Location of Construction: 28 Alice Ct lot 21		Owner: Chris Howard		Phone: 892-0026	Permit No: 001385
Owner Address:		Lessee/Buyer's Name:	Phone:	BusinessName:	
Contractor Name: Origins Landscaping		Address: **** Craig 879-6251****		Phone:	
Past Use: vacant/building in process		Proposed Use: single family		Permit Issued: DEC 8 2000	
Proposed Project Description: 3 amendment #2 to permit 000558 add retaining wall		COST OF WORK: \$ 19,000		PERMIT FEE: \$ 138.00	
		FIRE DEPT. <input type="checkbox"/> Approved <input type="checkbox"/> Denied		INSPECTION: Use Group: 130 Type: 93	
		Signature:		Signature: <i>[Signature]</i>	
		PEDESTRIAN ACTIVITIES DISTRICT (P.A.D.)		Zoning Approval: 386A-B-021	
		Action: <input type="checkbox"/> Approved <input type="checkbox"/> Approved with Conditions <input type="checkbox"/> Denied		Special Zone or Reviews: <input type="checkbox"/> Shoreland <input type="checkbox"/> Wetland <input type="checkbox"/> Flood Zone <input type="checkbox"/> Subdivision <input type="checkbox"/> Site Plan maj <input type="checkbox"/> minor <input type="checkbox"/> mm

RE: 28 Alice Court (Lot 21)

RE: Certificate of Occupancy – 106 Garsoe Drive (Lot 21)

PLOT PLAN
OF:
LOT 21 AU

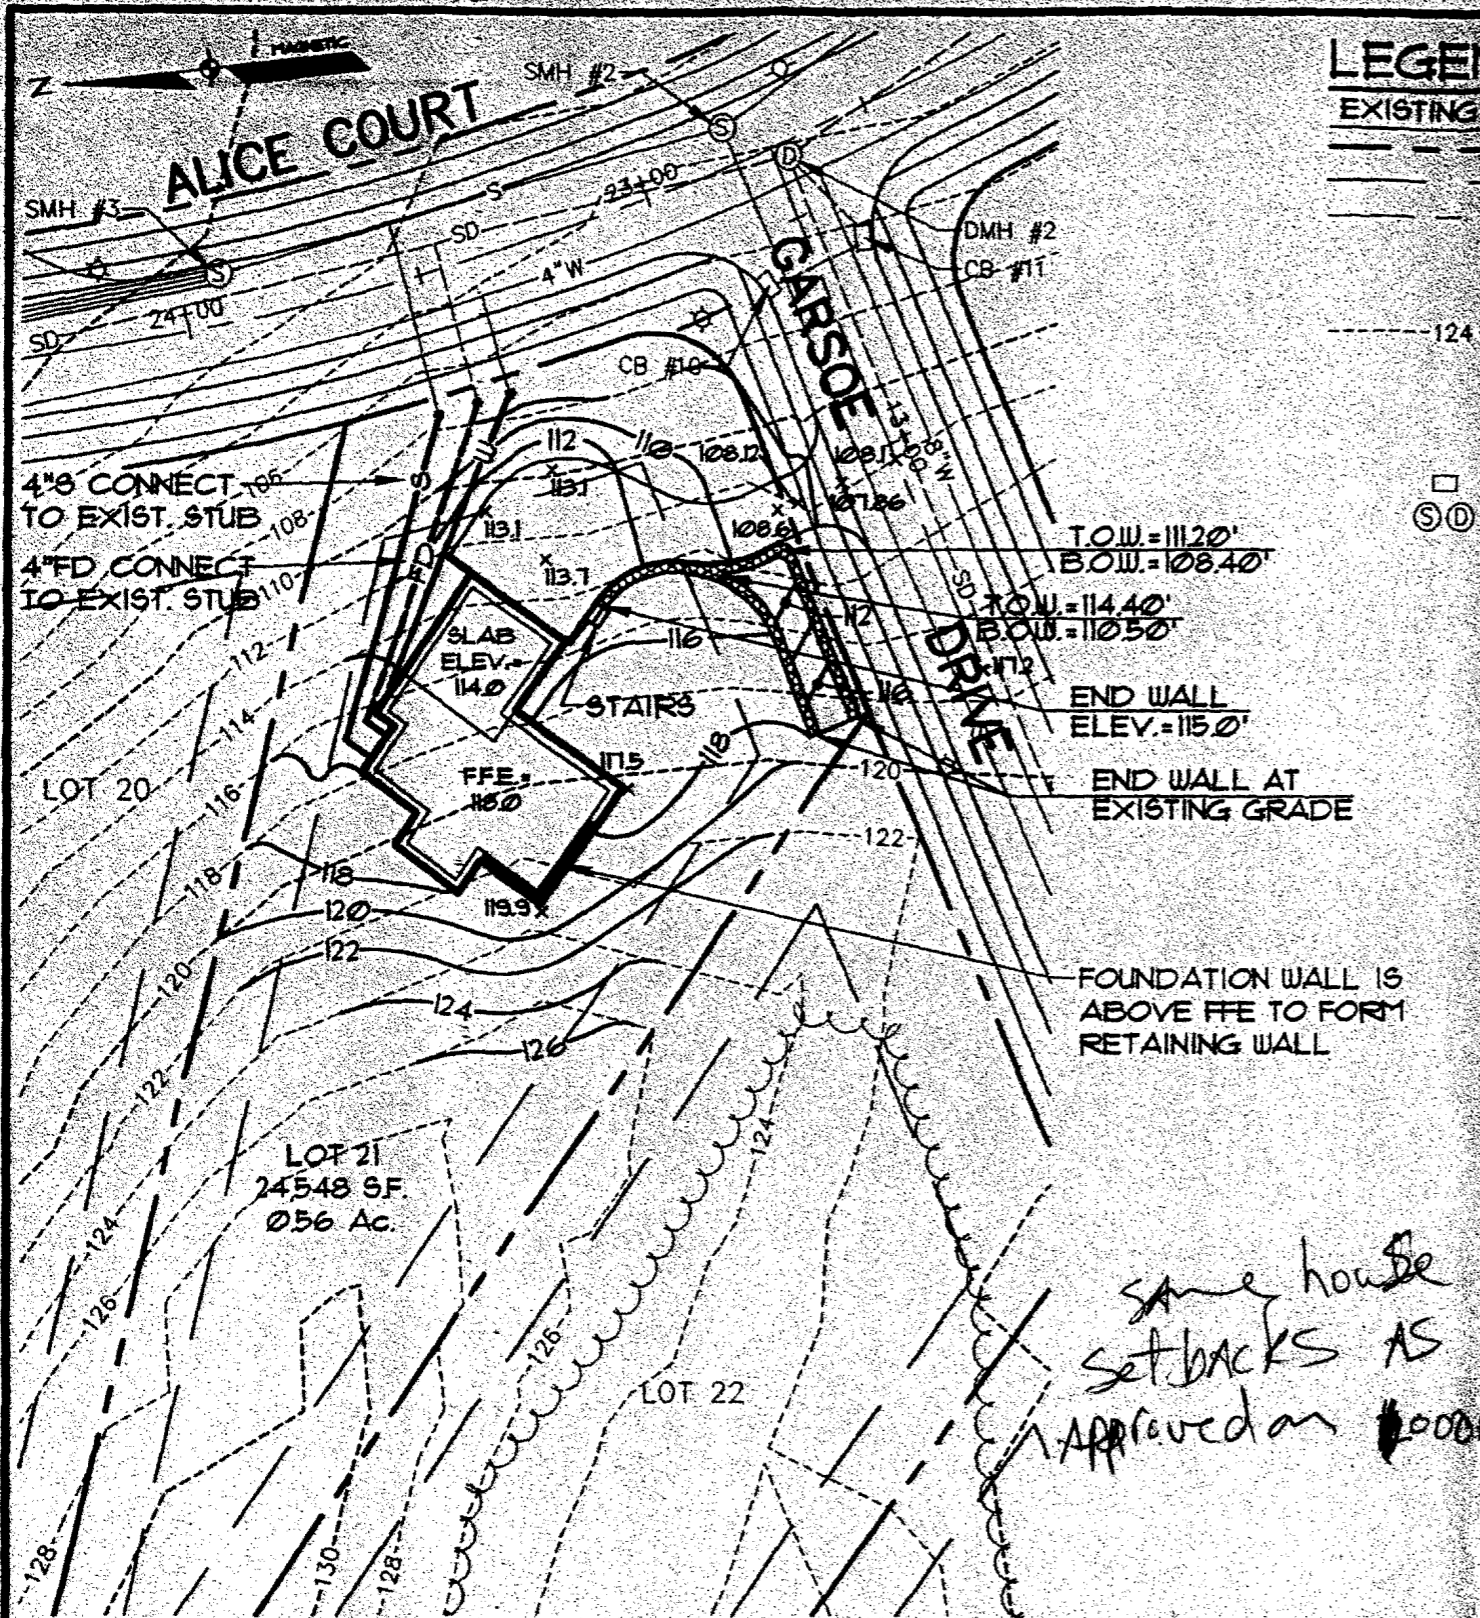
On December 7, 2000, the site was reviewed for compliance with the conditions of approval. My comments are:

1. Miscellaneous landscaping needs to be completed.
2. Stone wall along Garsoe Drive needs to be completed.

Due to the weather, neither of these will be completed this year.

It is our opinion that a **temporary certificate of occupancy** could be issued, assuming neither Code Enforcement nor Public Works has any outstanding issues. However, these items shall be completed by June 1, 2001 and be approved prior to the issuance of a permanent certificate of occupancy.
